**PLANNING COMMISSION
CONDITIONAL USE PERMIT
SITE PLAN REVIEW SHEET**

CASE NUMBER: SPC-2009-0044C(R2) **PC DATE:** October 25, 2016

PROJECT NAME: Animal Services Center

OVERALL
SITE PLAN EXHIBIT

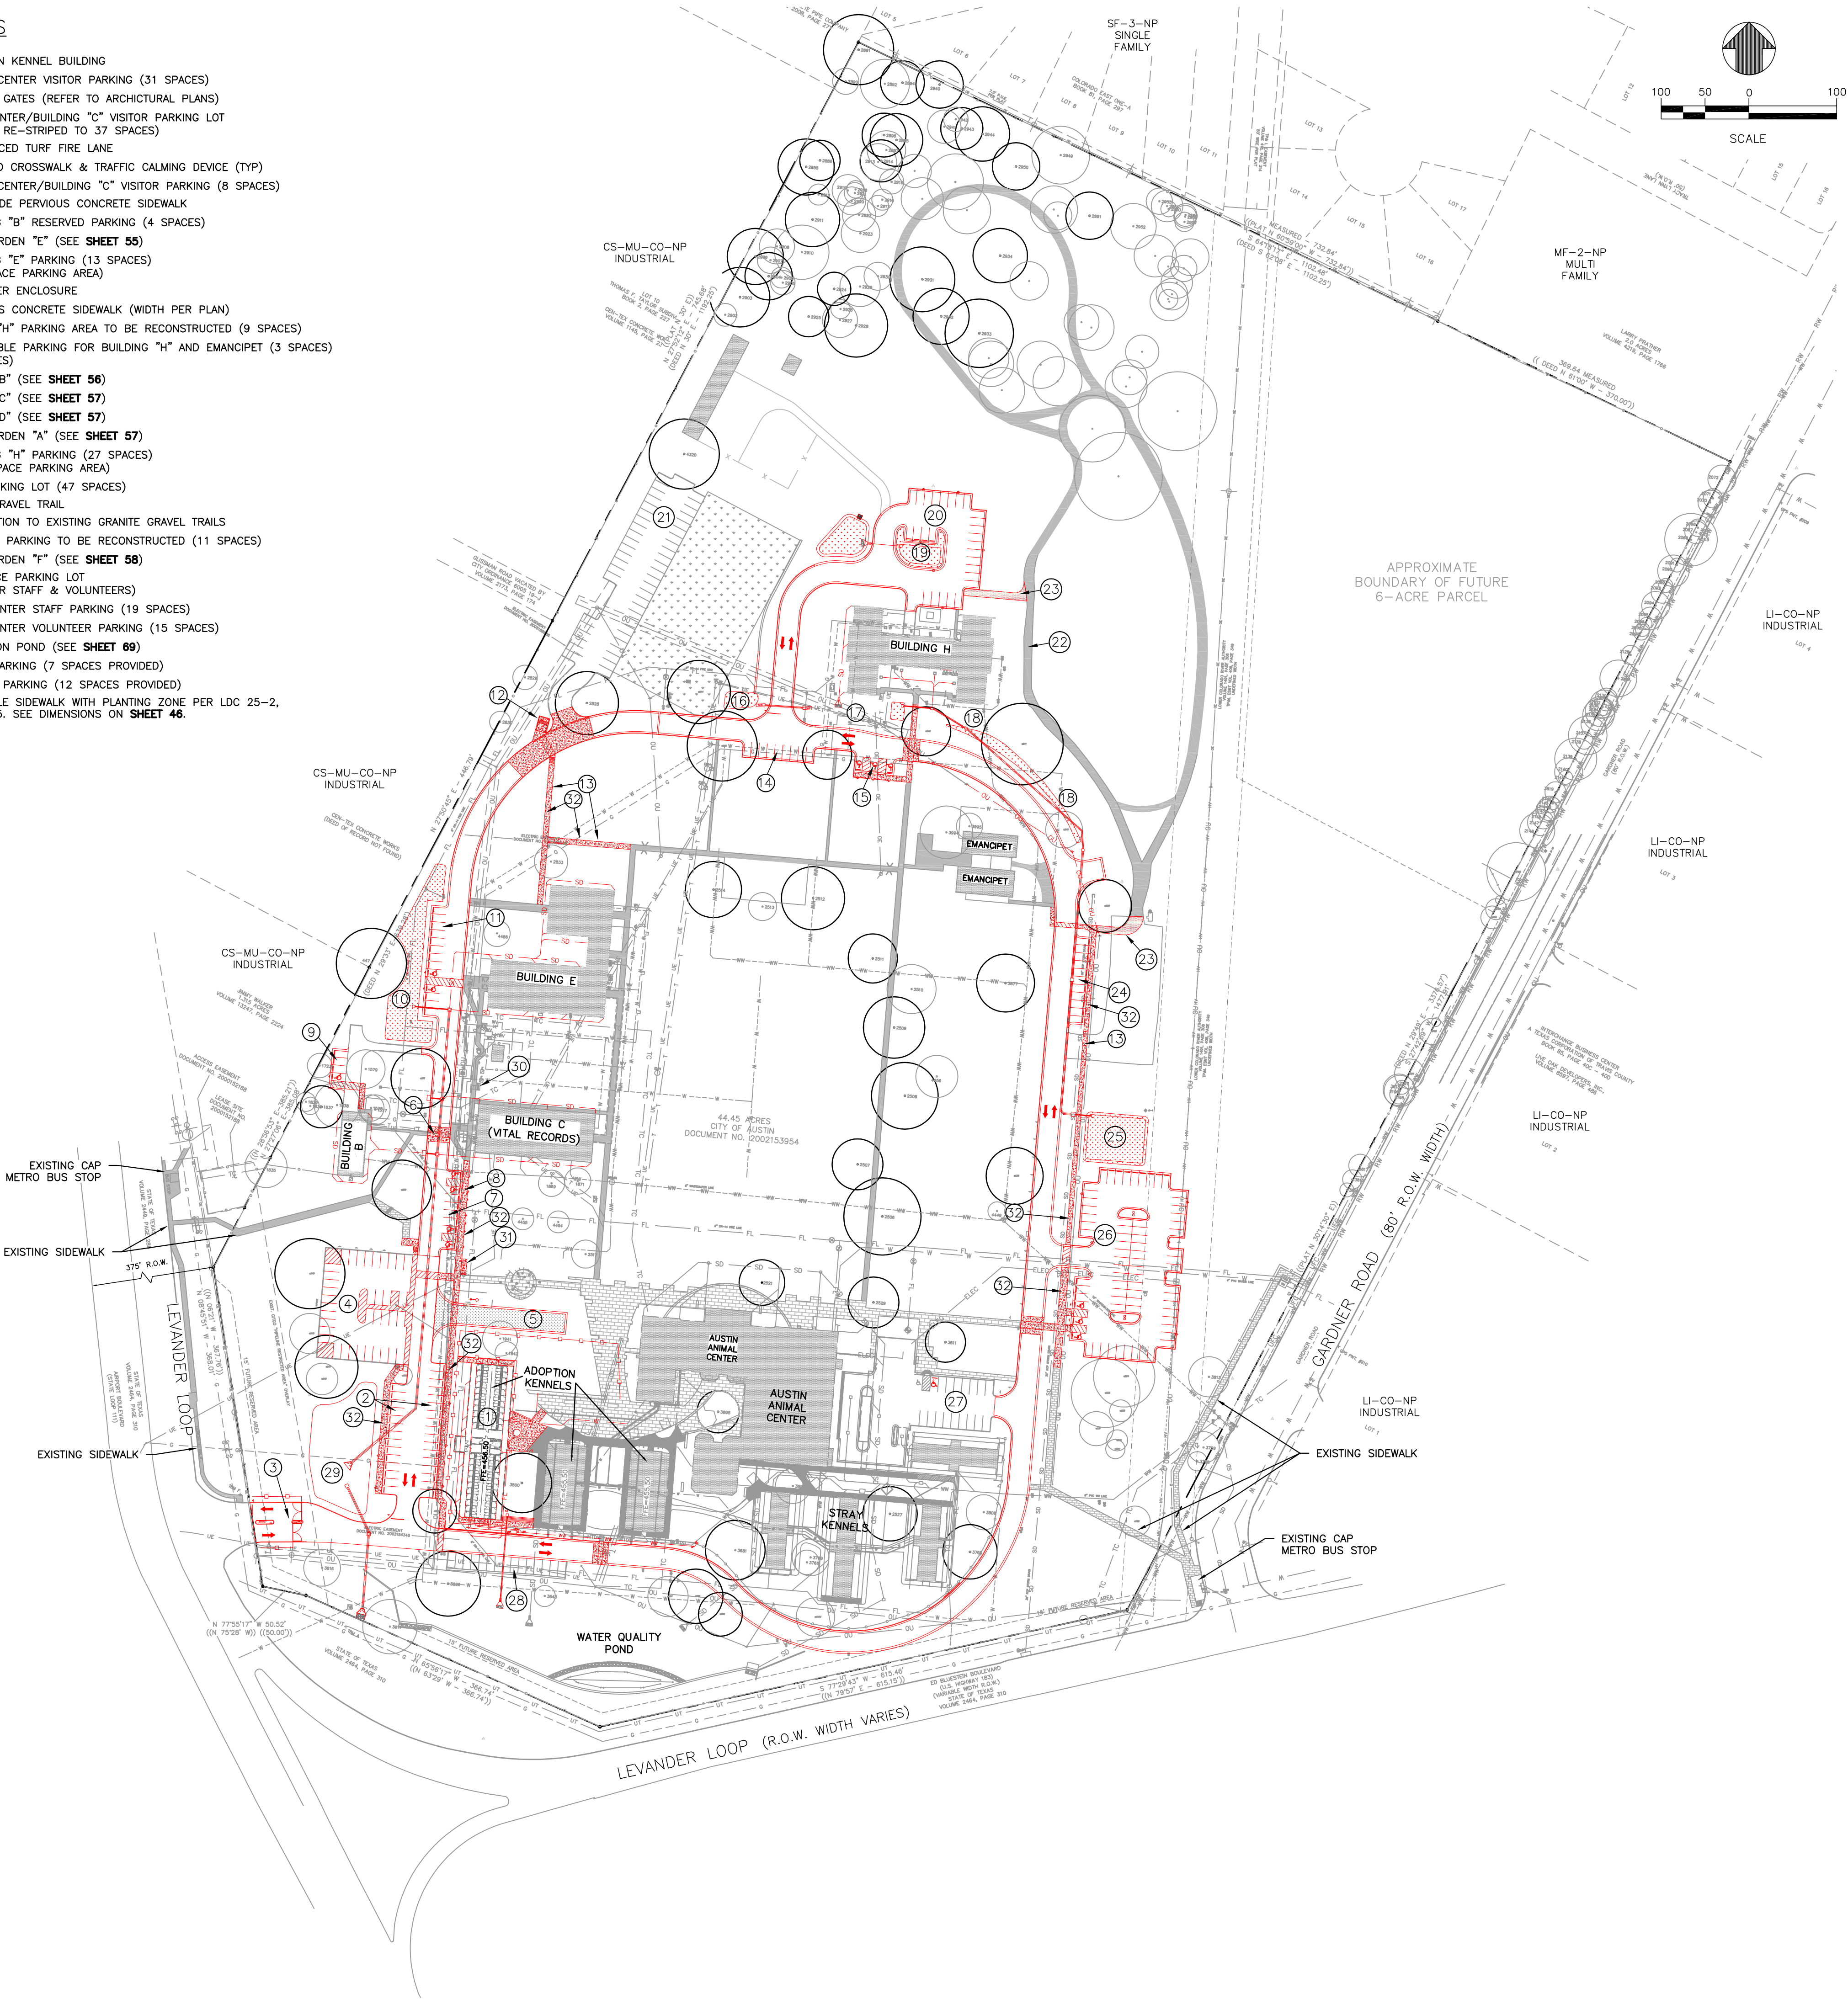
Transportation: The internal drive will be completely resurfaced, and widened; it's currently in poor condition, causing issues within the fire lane with significant pot holes. Eighty-nine new parking spaces will be provided within 2 new parking lots, both having direct access from the internal drive.

All access will continue to be taken from Levander Loop. Additional pedestrian connections, via sidewalks will be provided to comply with Subchapter E, along one of the parking areas, and to also connect the other parking area to the existing building and internal drive. The site plan has met all Transportation requirements.

Environmental: Several rain gardens are proposed to address water quality requirements as well as the increase in impervious cover, and for localized drainage control. The site is not located over the Edward's Aquifer Recharge Zone. The site is in the Desired Development Zone. The site is in the Colorado River and Boggy Creek watershed, which is classified as a suburban watershed. There are no environmental features or critical water quality zones affected by this project.

Staff recommends approval of the revision. The changes and improvements are in association to the existing animal center and offices on site and will not increase the intensity of the site, nor include additional land uses.
